Stage 5: Draft Final Modification Report		At what stage is this document in the process?
<h1 style="color: #00a651;">GC0096</h1> <h2 style="color: #00a651;">Modification Title: Energy Storage</h2>		<div style="display: flex; flex-direction: column; align-items: center;"> <div style="display: flex; border: 1px solid #ccc; border-radius: 5px; margin-bottom: 5px; width: 100%;"> <div style="border-right: 1px solid #ccc; padding: 5px; text-align: center;">01</div> <div style="padding: 5px;">Proposal Form</div> </div> <div style="display: flex; border: 1px solid #ccc; border-radius: 5px; margin-bottom: 5px; width: 100%;"> <div style="border-right: 1px solid #ccc; padding: 5px; text-align: center;">02</div> <div style="padding: 5px;">Workgroup Consultation</div> </div> <div style="display: flex; border: 1px solid #ccc; border-radius: 5px; margin-bottom: 5px; width: 100%;"> <div style="border-right: 1px solid #ccc; padding: 5px; text-align: center;">03</div> <div style="padding: 5px;">Workgroup Report</div> </div> <div style="display: flex; border: 1px solid #ccc; border-radius: 5px; margin-bottom: 5px; width: 100%;"> <div style="border-right: 1px solid #ccc; padding: 5px; text-align: cent

Figure 2

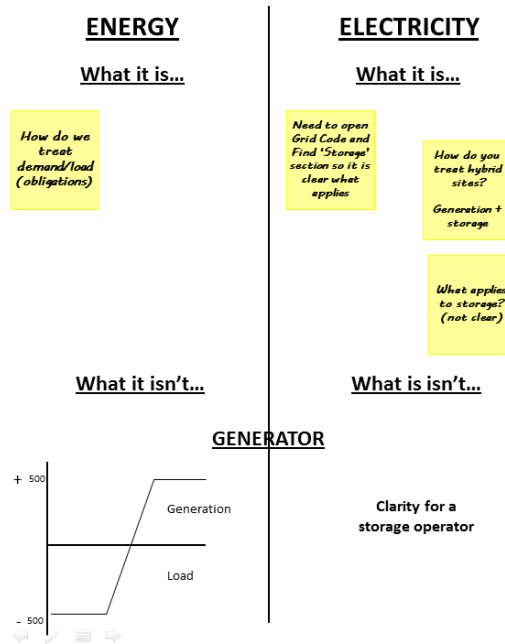
It was noted by the Proposer that at the two workshops in August 2016, industry developed an initial thought on a definition for Electricity/Energy Storage which can be seen in figure 2 below. Following a Workgroup debate, the Workgroup determined that the correct definition to use was ‘Electricity Storage’ and that any definition should be technology neutral and setting a minimum standard noting that users can exploit their full operational flexibility through commercial services arrangements/ markets (e.g. Enhanced Frequency Response).

At the third Workgroup meeting, a Workgroup member voiced an important clarification. Added to the definition for Electricity Storage was the ability for the Storage Facility Owner to be able to *control* the ‘conversion’ and ‘reconversion’ of that electrical energy – an important clarification to ensure a sufficient level of response to system-need for the technologies in question.

The addition of “in a controllable manner” was added to exclude certain technologies such as Synchronous Compensators, Synchronous flywheels and Regenerative Braking Systems which would otherwise struggle to meet the proposed technical requirements. It is also worth noting that storage technologies would only be required to meet the proposed technical requirements when they have sufficient capability – e.g. a battery is sufficiently charged or other storage device is sufficiently fuelled. In other words, if a storage device was completely discharged, there would be no requirement for it to satisfy any of the exporting requirements although the requirements for import would still apply - in just the same way as a generator which had no fuel would have no requirement to satisfy those same exporting requirements.

Figure 2.0

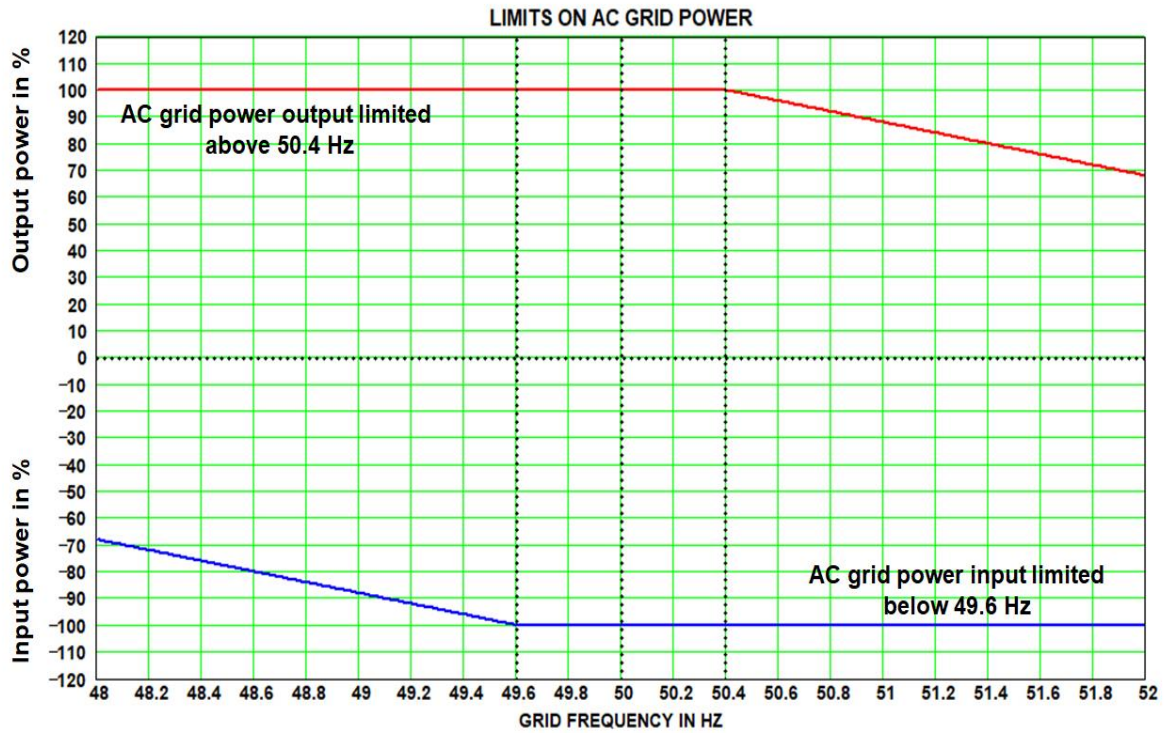
As part of the Workgroup discussions, one Workgroup member noted that storage should have a requirement to cater for limiting power input with falling frequency and limiting power output with rising frequency and proposed the use of the following graph.

The Proposer would however note that the characteristic shown in Figure 2.0 may be more appropriate however as also pointed out by a workgroup member this requirement applies to generation equally as it applies to Storage. As such, and as the aim of the workgroup is to ensure consistent treatment between different classes of User's, this is an issue that should be highlighted as a future area of work as the implications of a change to generation affects a much greater audience.

Figure 3.0 (a)

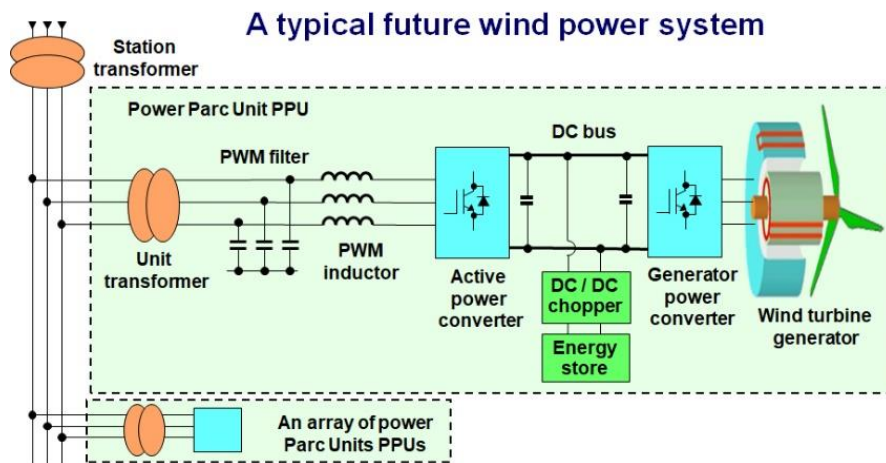
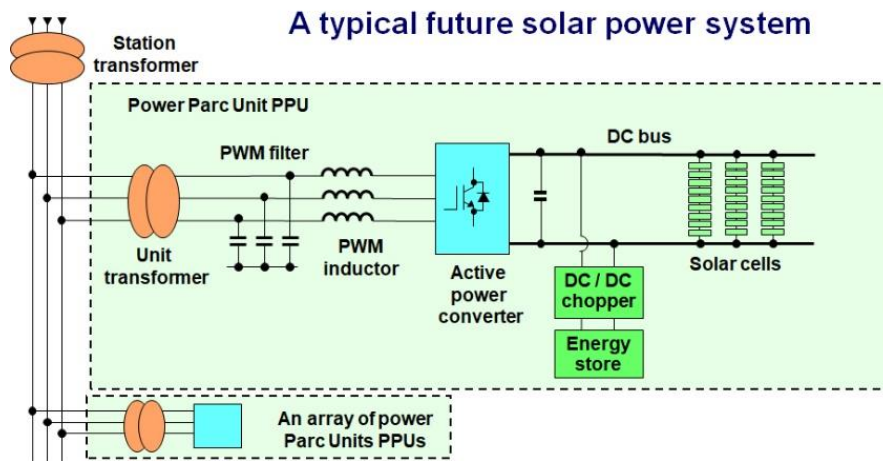
In addition, a Workgroup Member noted that as part of a future co-located site that it was entirely likely that an energy storage technology could be integrated as part of a solar park, wind farm or synchronous plant. Figure 3.0(a) and Figure 3.0(b) below (which have been re-produced in this report with the kind permission of ENTSO-E) illustrate this example for a wind farm or solar park.

One Workgroup member noted that for wind farms and solar parks, the storage elements are not directly connected to the AC system and raised concern that they would not be required to satisfy the requirements of the GC0096 proposals. It was also noted that for rotating synchronous generators this is not so much of an issue.

In response, the Proposer would note that where you have a Power Station comprising of Power Park Modules and/or Electricity Storage Modules, the Grid Code applies to the Power Park Modules and Electricity Storage Modules within that Power Station.

In addition, the Proposer would note that as part of the GC0096 proposals, that when a storage element is operating in a condition analogous to demand, then there is a requirement for this demand to be reduced as frequency falls as defined under OC6.6, in just the same way as pump tripping as part of a pumped storage plant.
